NEW RIVER CENTRAL

DEVELOPMENT REVIEW COMMITTEE (DRC)

DEVELOPMENT REVIEW COMMITTEE (DRC) COMMENT REPORT

Request: Site Plan Level II Review: 408 Multifamily Units and 5697sf of Retail Use

Sheet Title
SITE PLAN

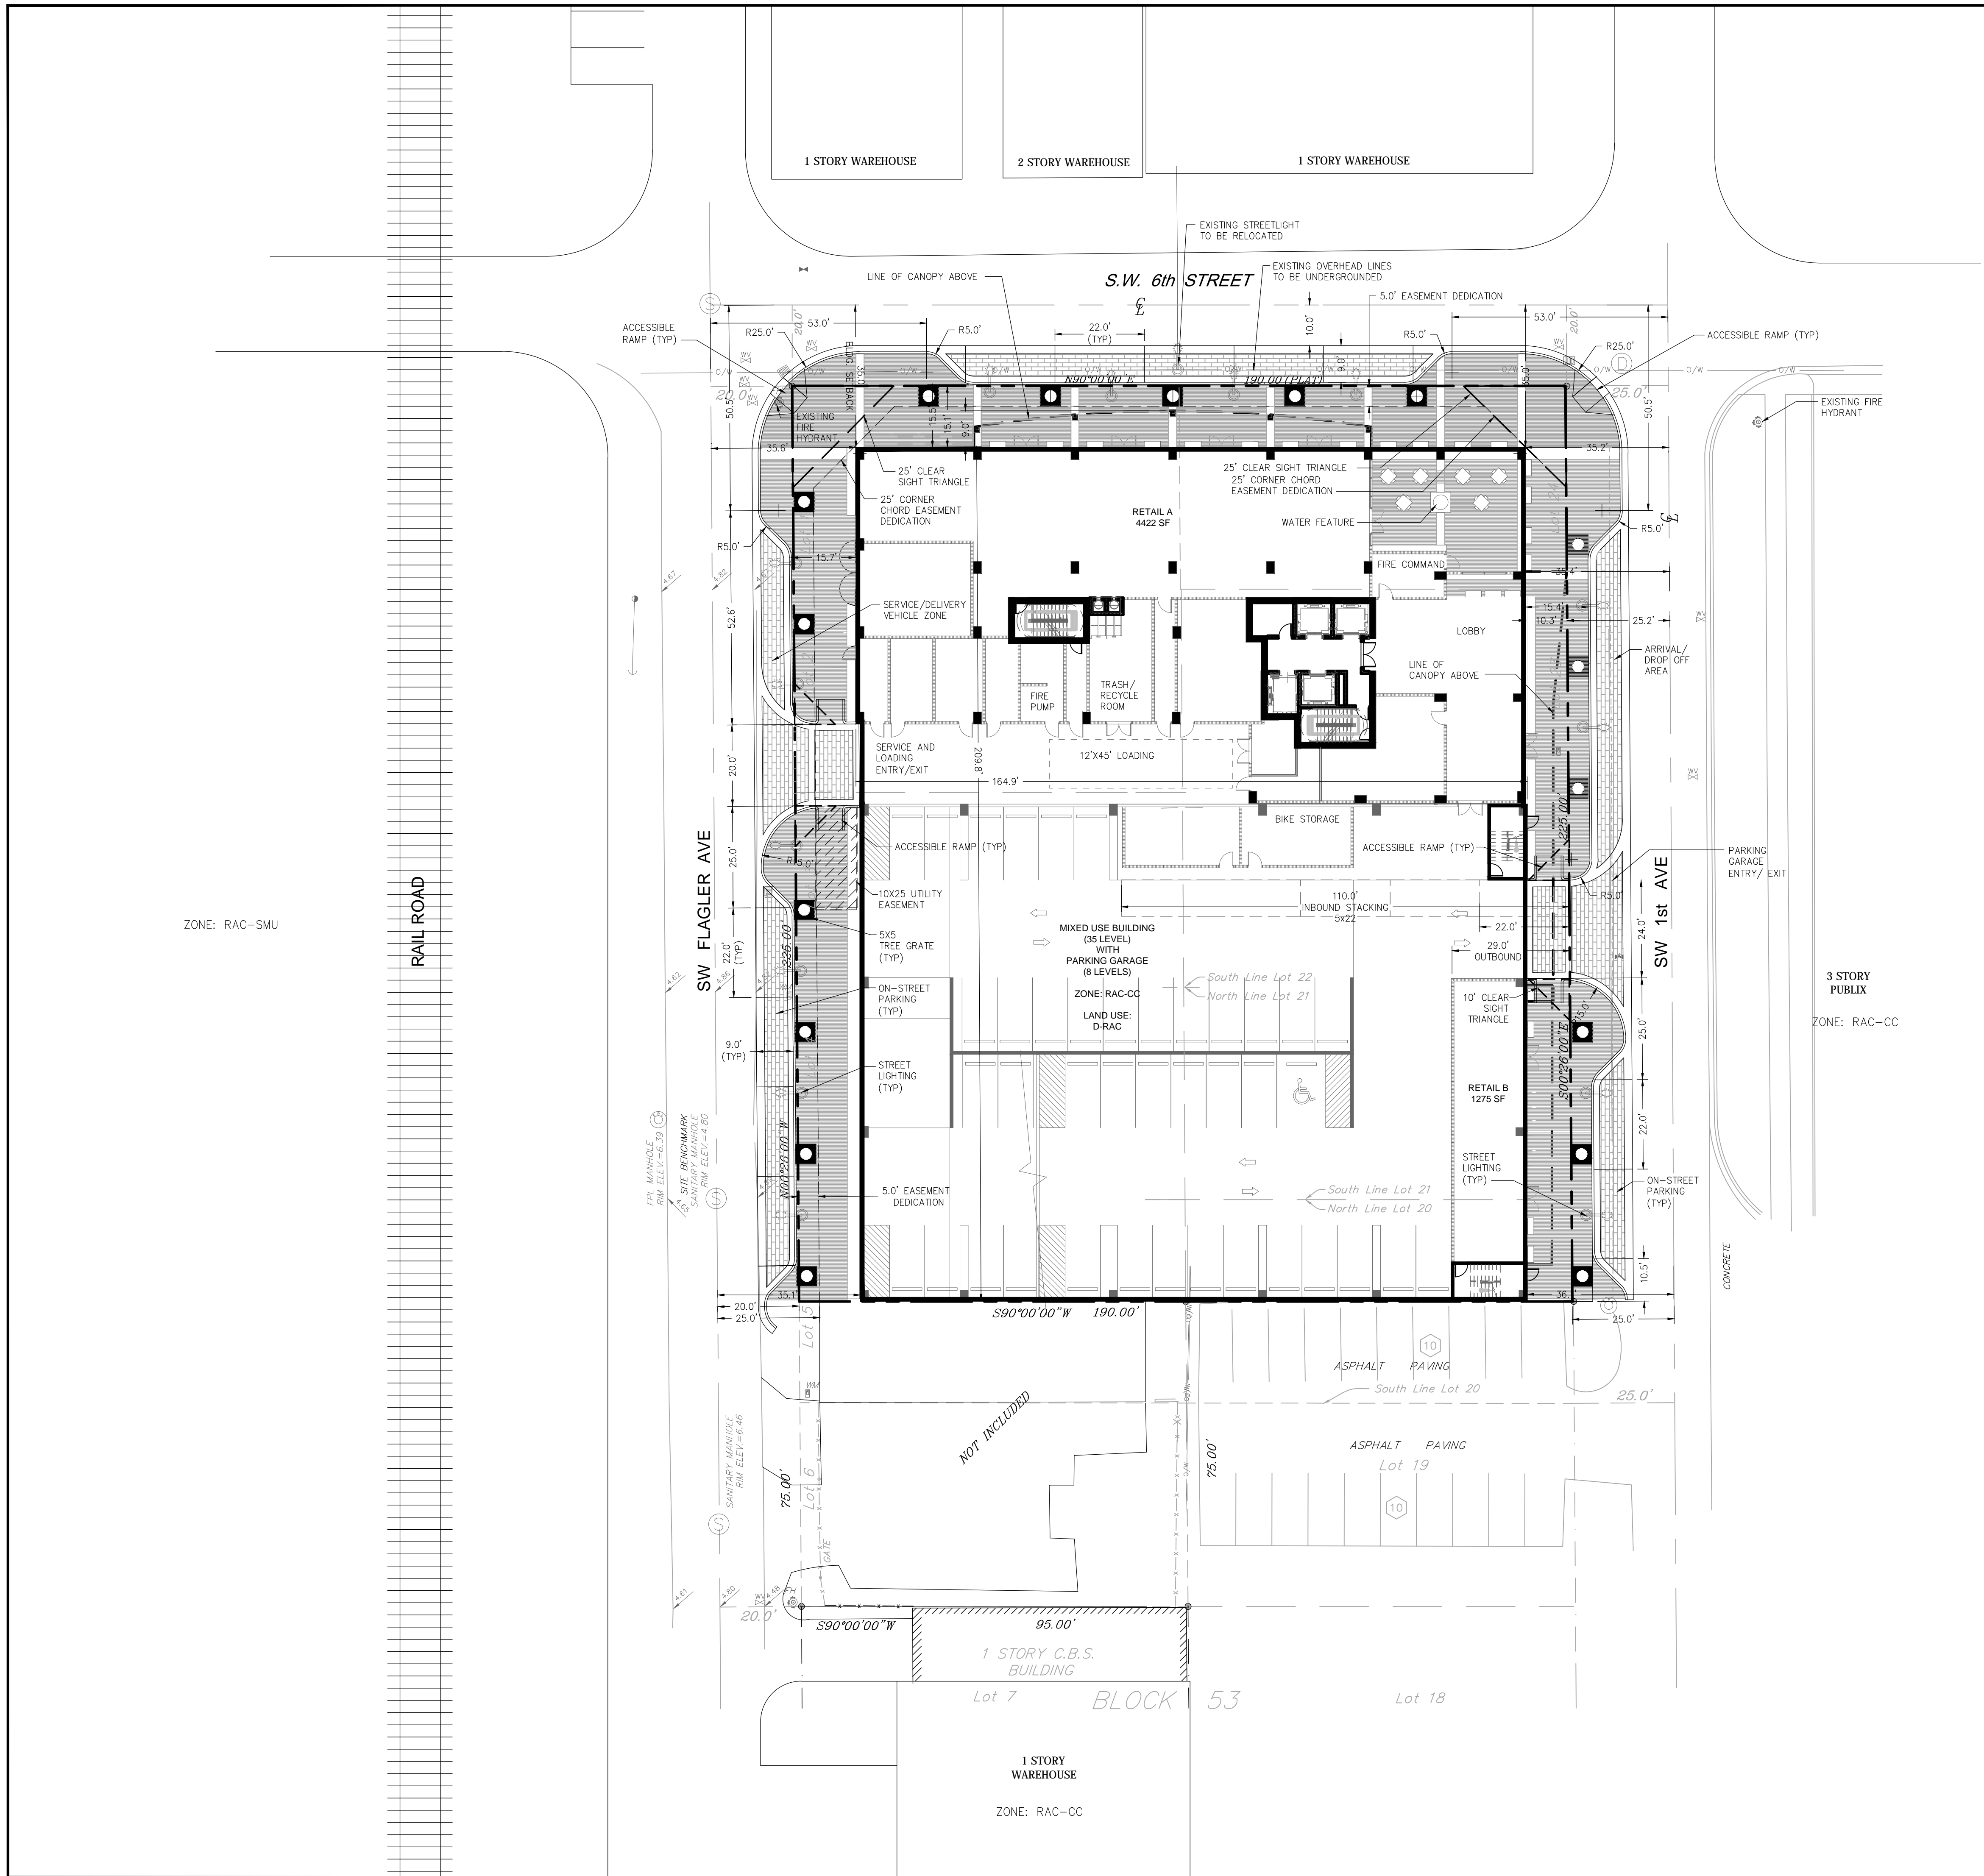
- a. Civil Sheet C1 – Northwest corner of proposed development, 25' Corner Chord Easement dedication should coincide with 25' Clear Sight Triangle (i.e. measured from existing Right-of-Way boundaries).

- e. Show and label on Site Plan 7' (min.) clear sidewalk width for public pedestrian access along development side of S.W. Flagler Avenue, S.W. 6th Street, and S.W. 1st Avenue

3. Civil Sheet C1 – 'Service/Delivery Vehicle Zone' shown and labeled along east side of S.W. Flagler Avenue, and 'Arrival / Drop-Off Area' shown and labeled along west side of S.W. 1st Avenue, are not allowed within City Right-of-Way or permanent easements; remove or replace with on-street parallel parking stalls.

4. Civil Sheet C1 – Discuss southern property boundary transition of curb & gutter and public sidewalk improvements, on both the S.W. Flagler Avenue and S.W. 1st Avenue sides of proposed development; coordinate with the City's Transportation & Mobility Department.
